ADDENDUM NO. 9

PROJECT NO. DGS C-0948-0090 PHASE 003

**PROJECT TITLE - Capitol Complex Central Plant - Building Renovations, Chiller System
Replacement and Electrical System Upgrades**

1 COOLING TOWER SUMP- MECHANICAL - DEMOLITION
SCALE: 1/4" = 1'-0"

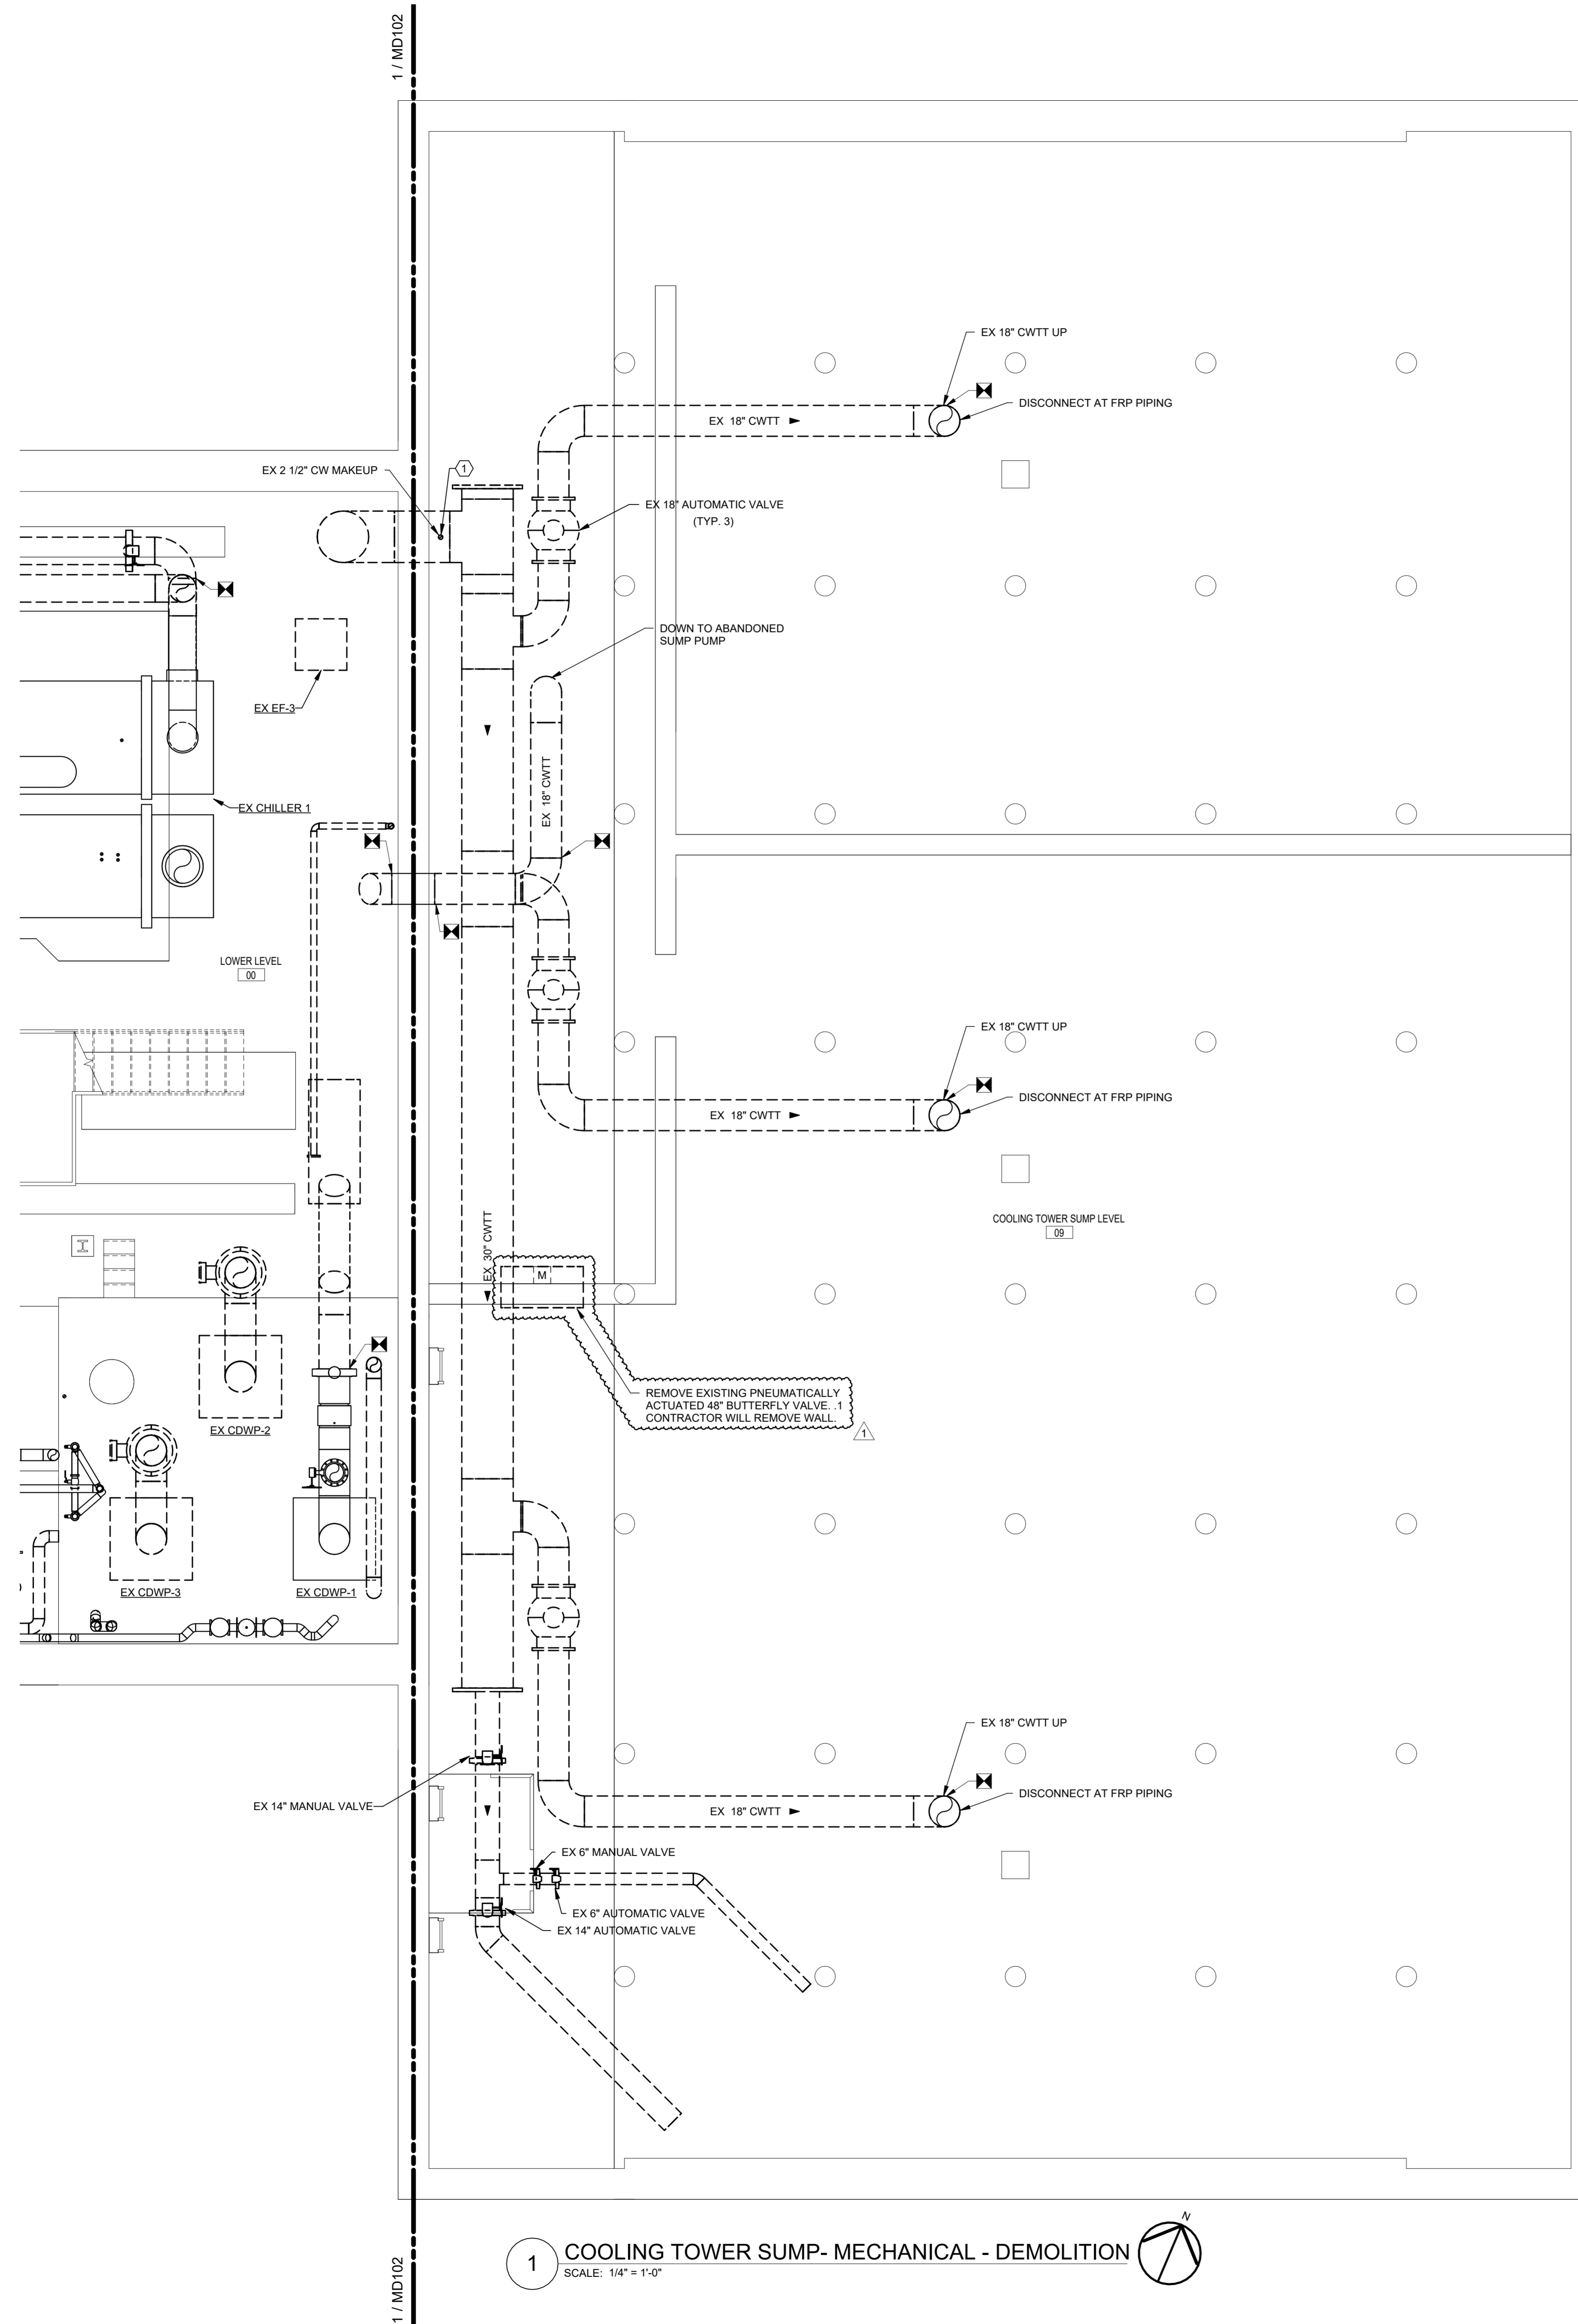
1. DISCONNECT AND REMOVE EXISTING COLD WATER MAKEUP AND ALL ASSOCIATED HEAT TRACING.
